工程指示 / 要求簡箋(E.I.)

工程指示編號：EI / 7232 / 24                      修改版次：B  
 工程編號           ：J - 858                              工程名稱       ：將軍澳日出康城  
 工程項目           ：後加 AC Grille (T2 9/F AF Mock Up) 圖紙上載 2<sup>nd</sup> submission  
 收件人               ：生統 / 拆圖                              發件人        ：Paul Wong                              日期：22/02/2024

**PROPOSED RESIDENTIAL DEVELOPMENT  
AT TKOTL 7ORP, PHASE 11, LOHAS PARK, TSEUNG KWAN O, N.T.**

**TITLE : SHOP DRAWING FOR  
ALUM. A.C. GRILLE & WATER CABINET AT 9/F FOR TOWER 2A-FLAT F (MOCK UP)**

TITLE :  
ALUM. A.C. GRILLE & WATER CABINET  
AT 9/F  
FOR TOWER 2A-FLAT F  
PART PLAN

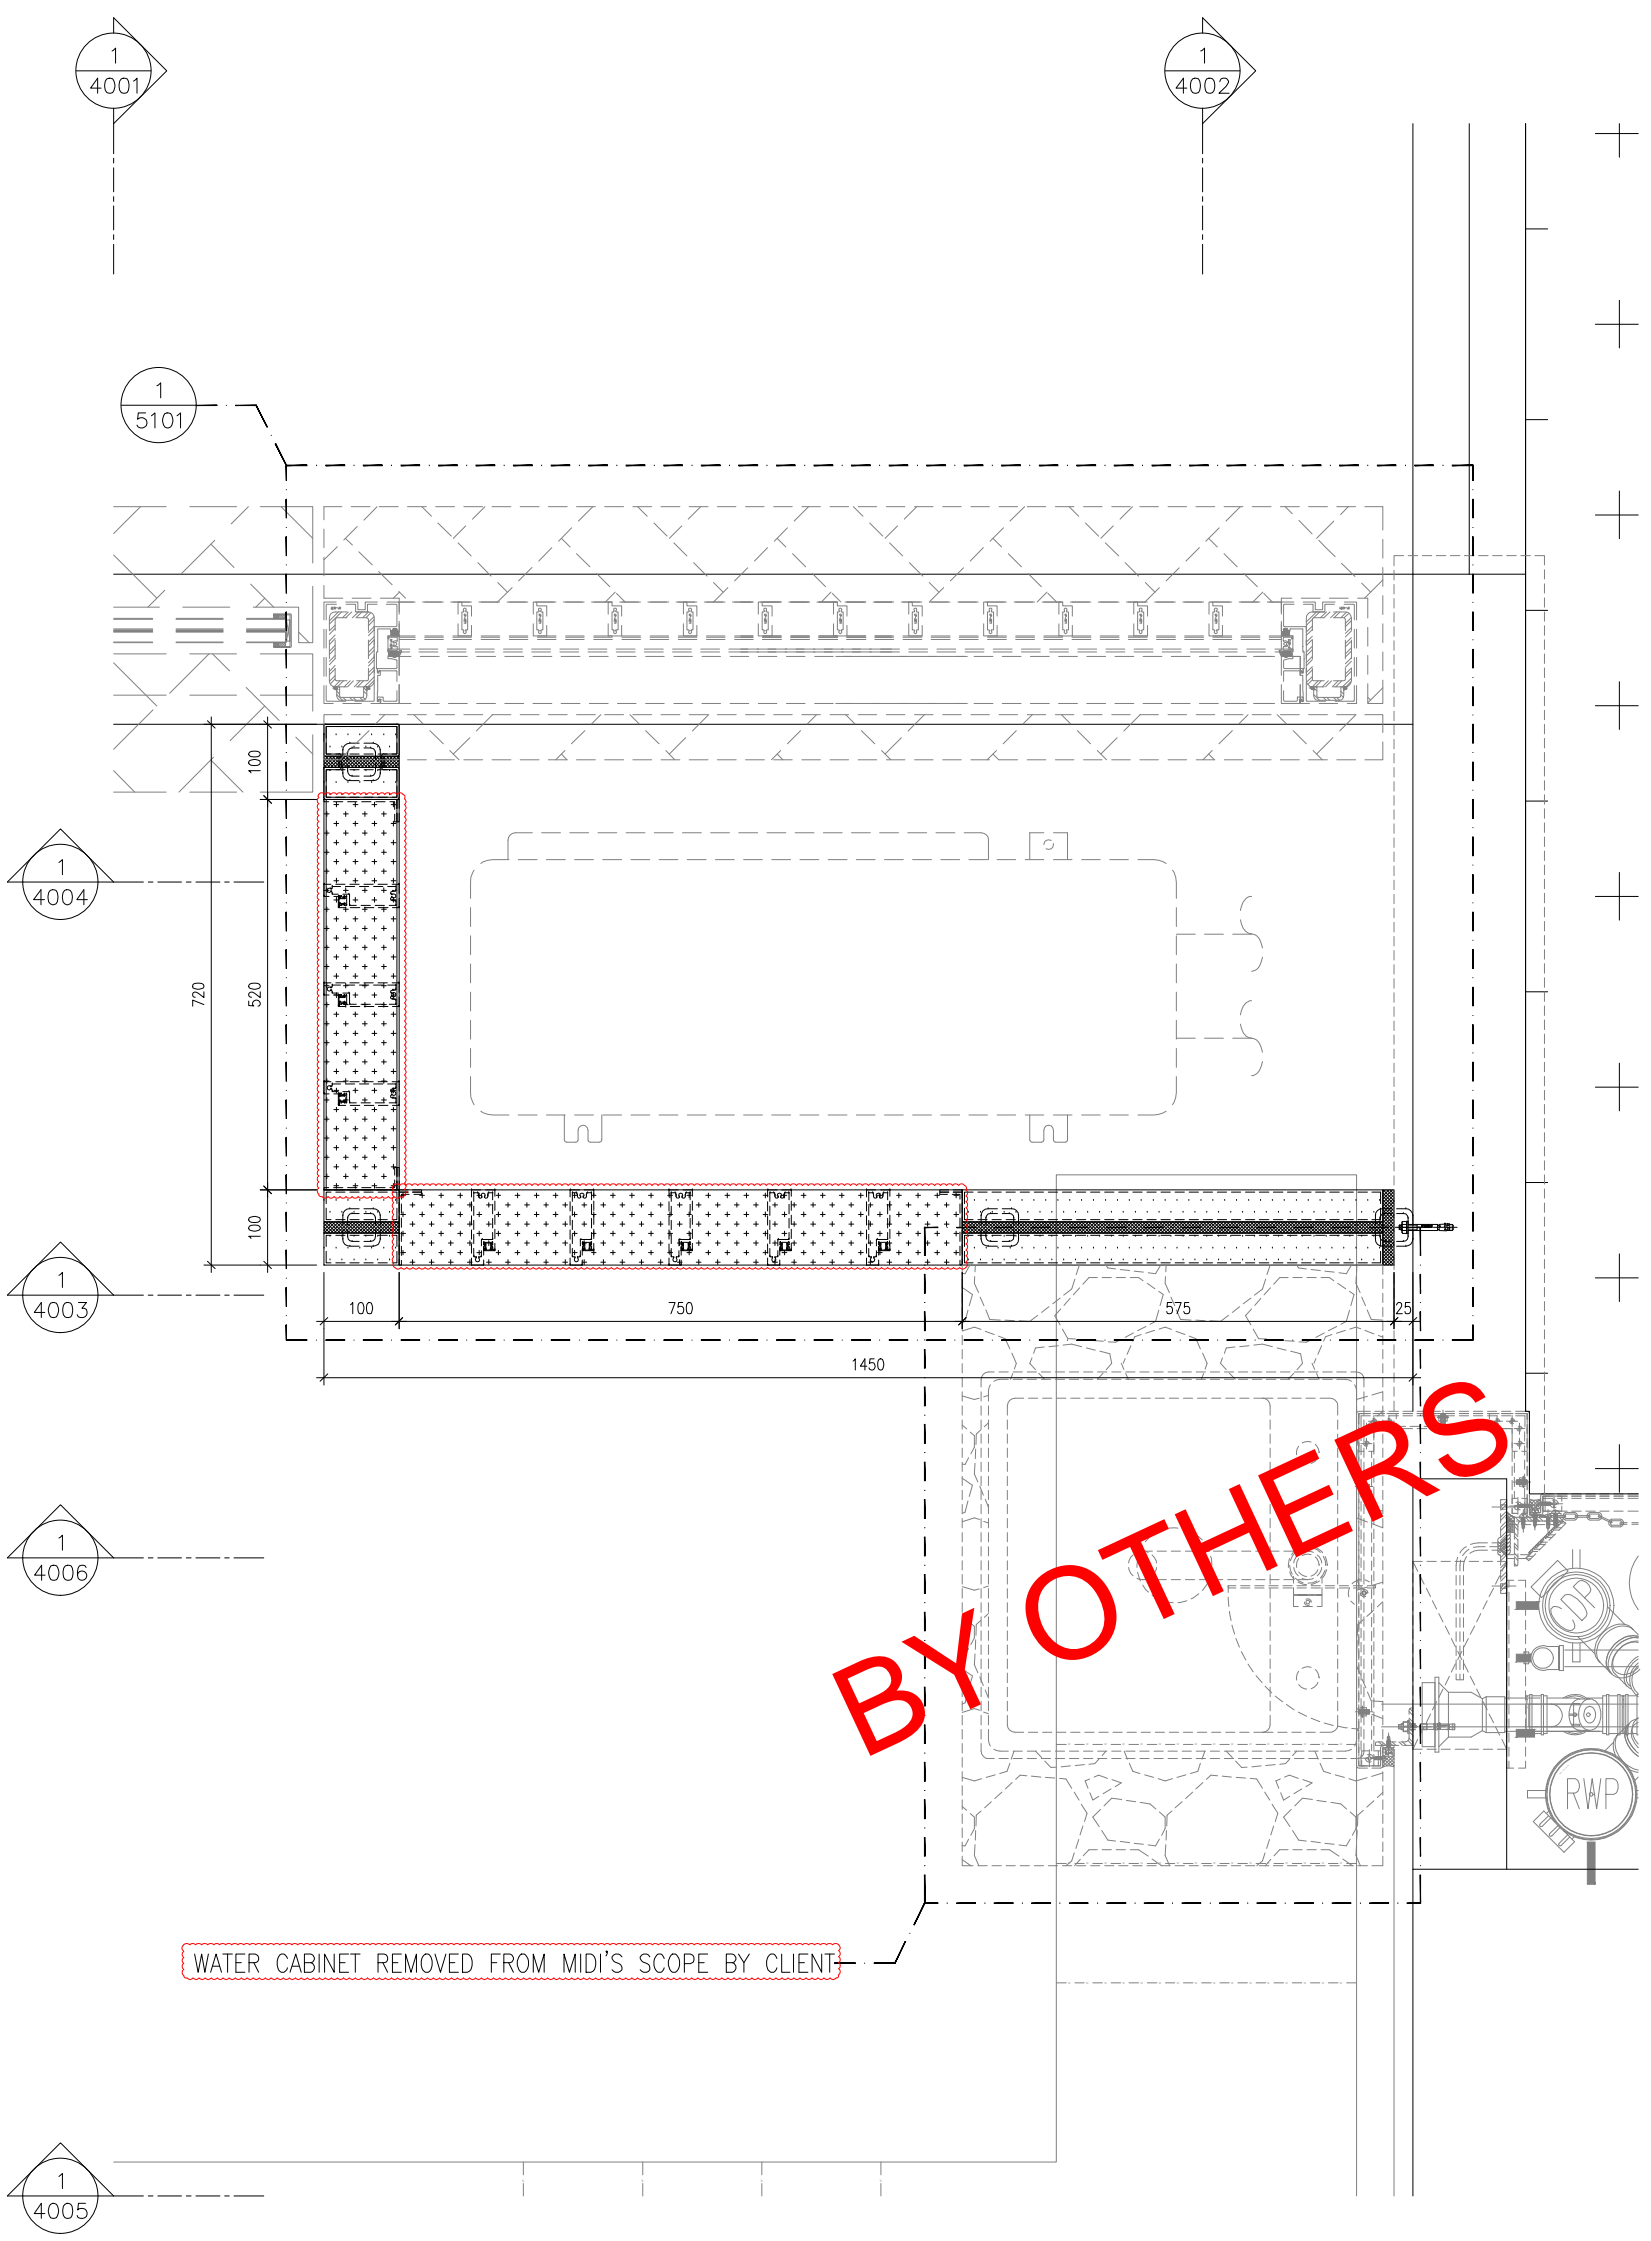
WATER CABINET REMOVED FROM MIDI'S SCOPE BY CLIENT

TITLE :  
ALUM. A.C. GRILLE & WATER CABINET  
AT 9/F  
FOR TOWER 2A-FLAT F  
ELEVATION

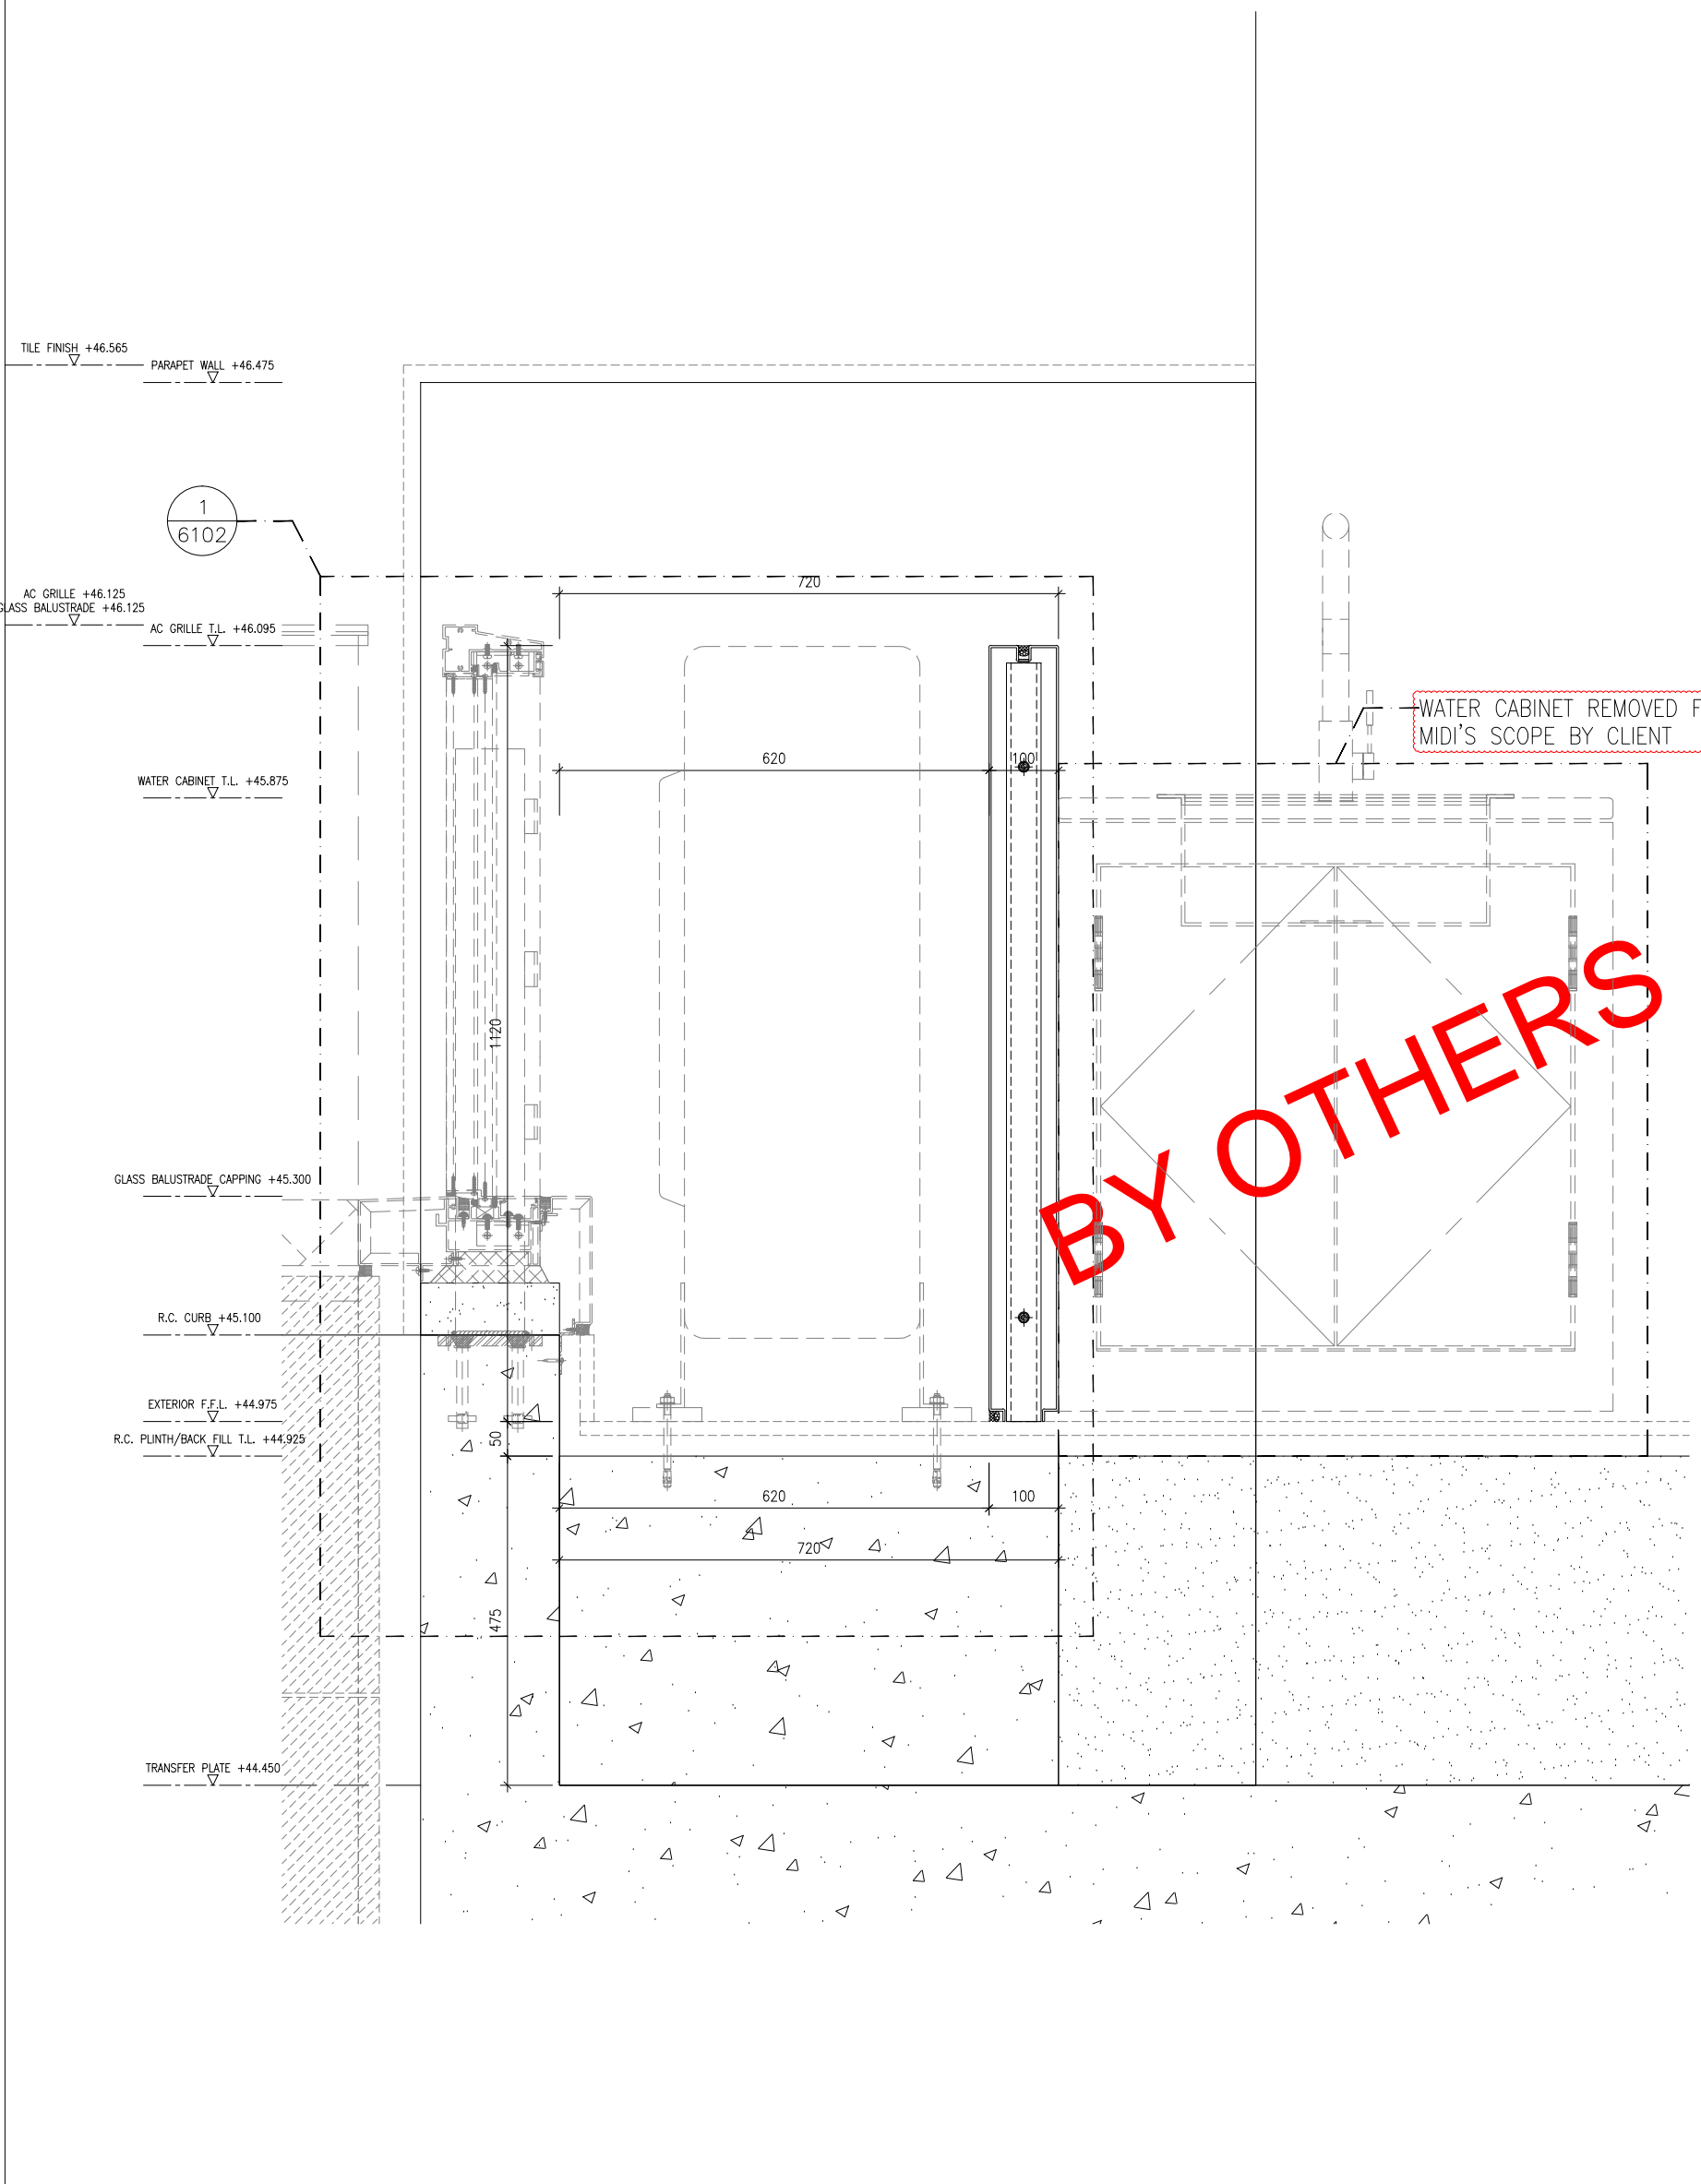
WATER CABINET REMOVED FROM MIDI'S SCOPE BY CLIENT

FOR TOWER 2A-FLAT F  
ELEVATION

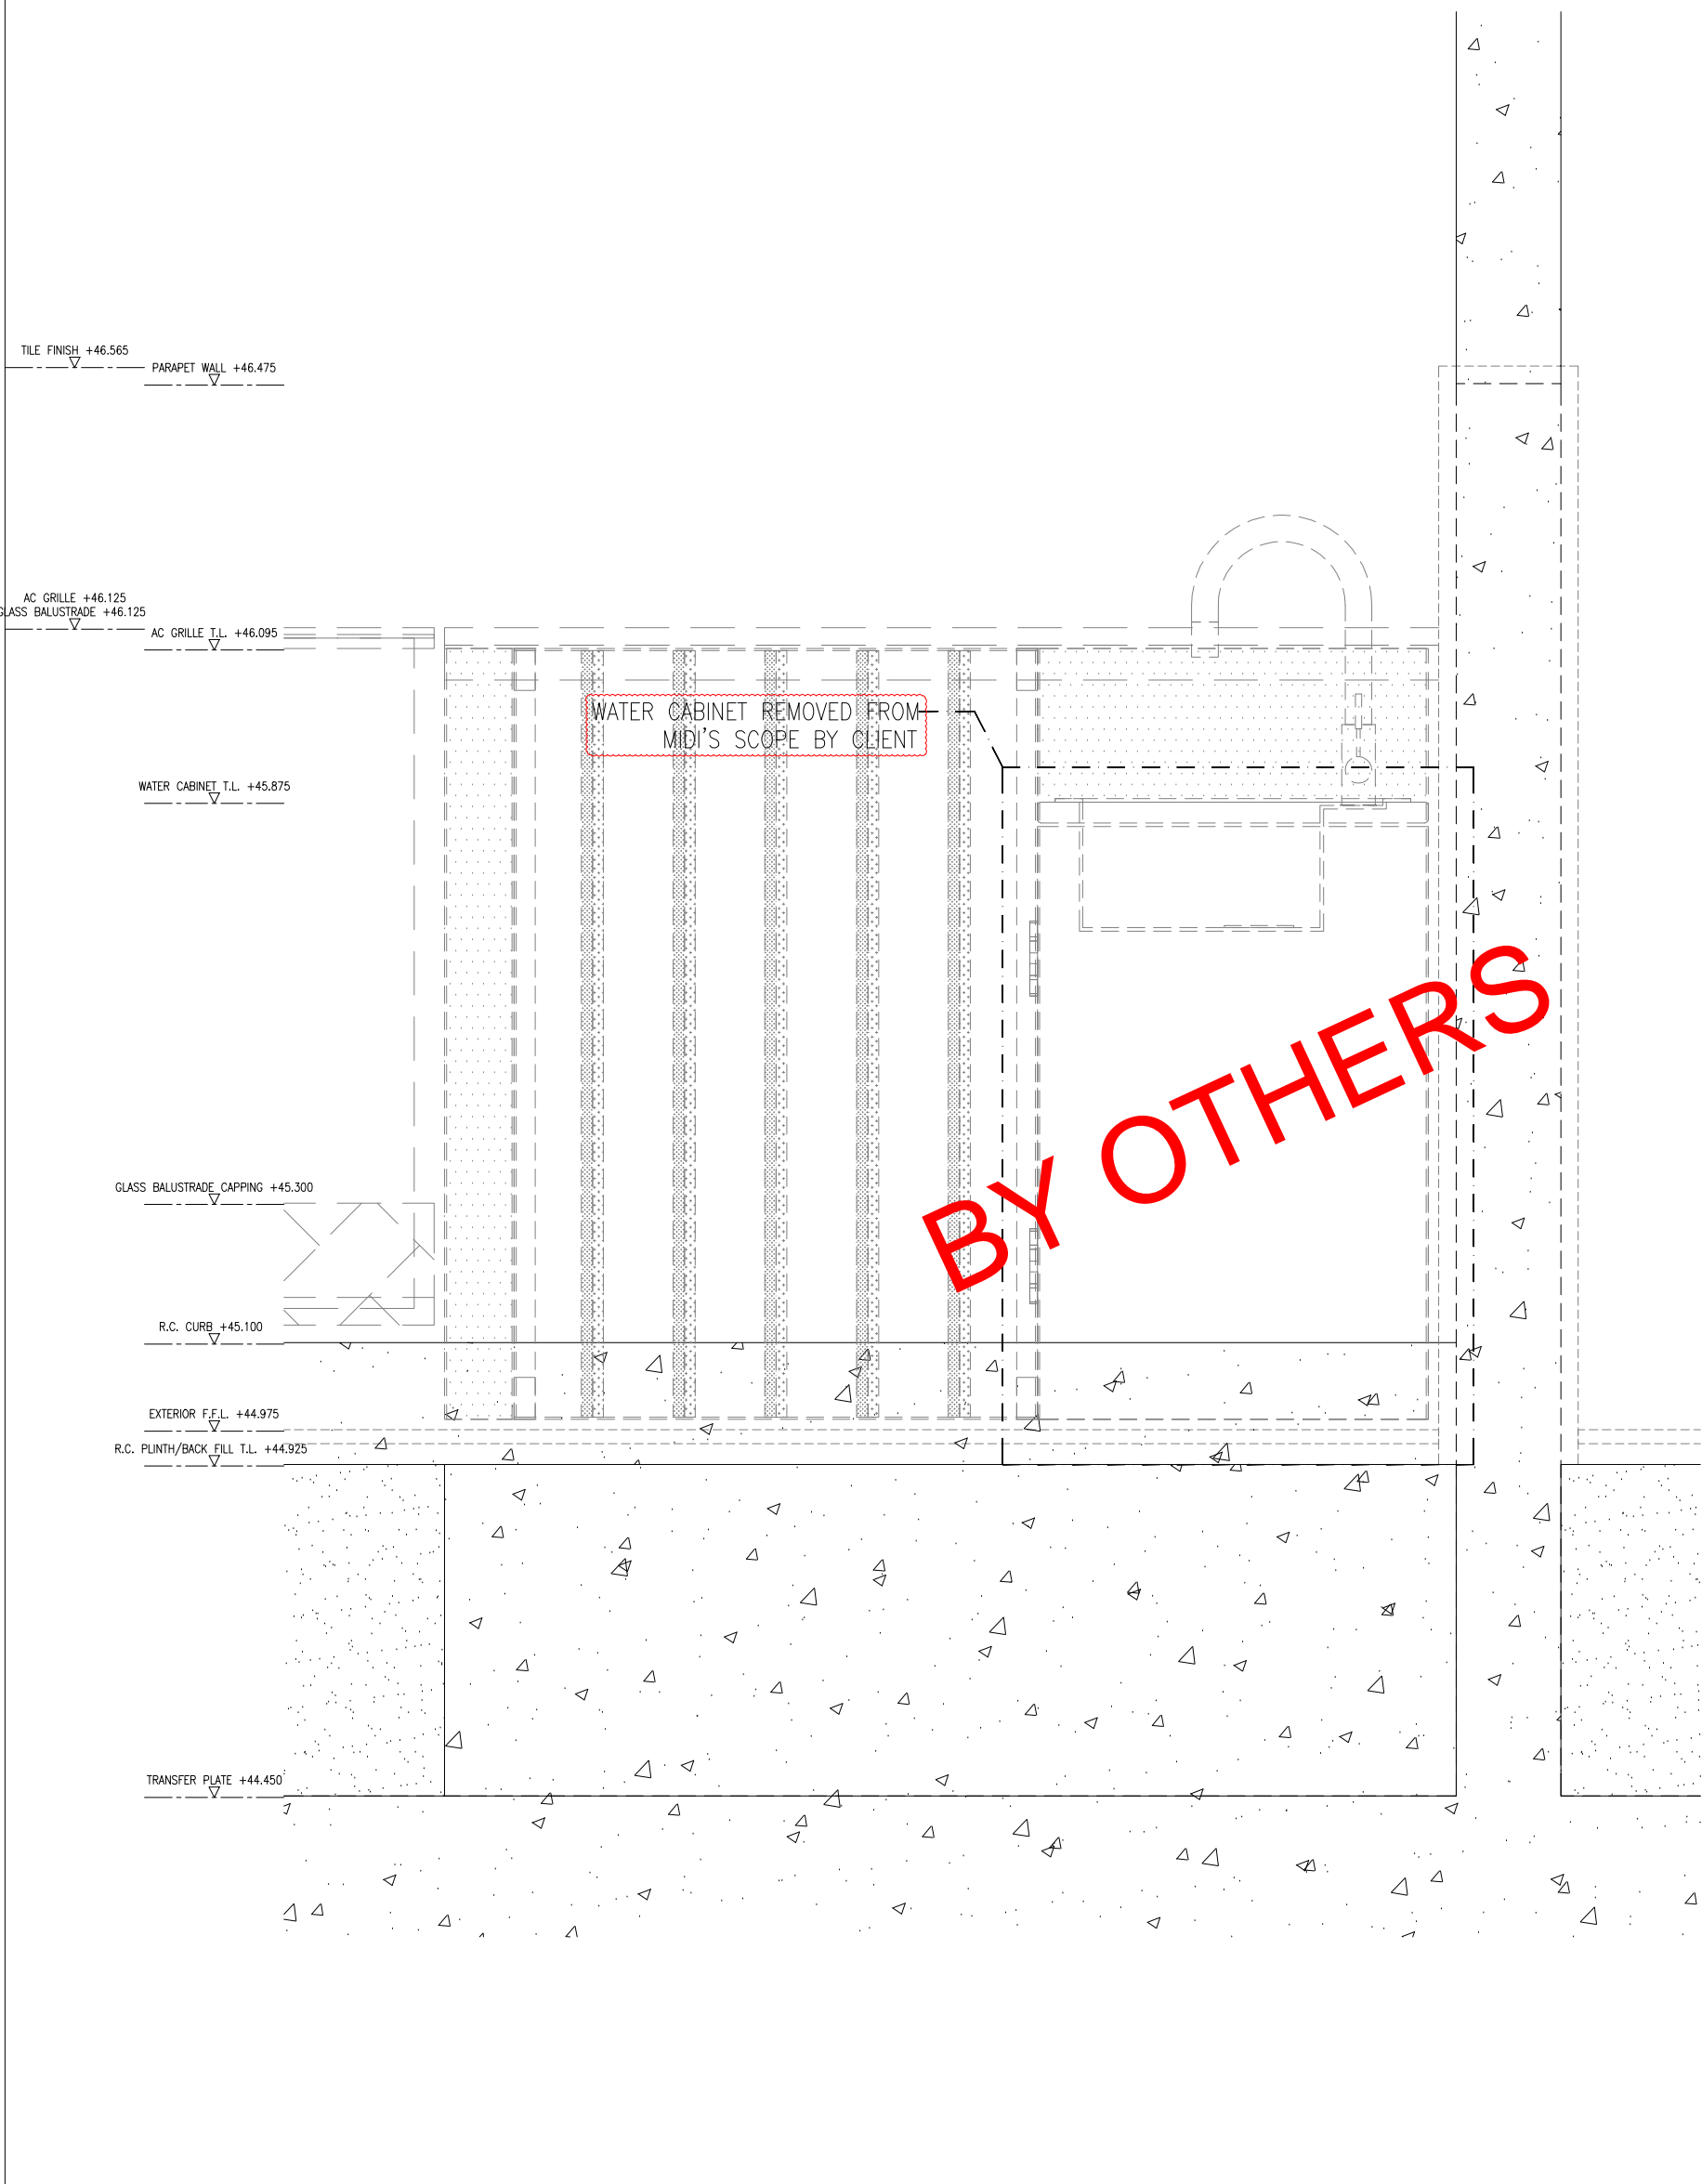
WATER CABINET REMOVED FROM  
MID'S SCOPE BY CLIENT
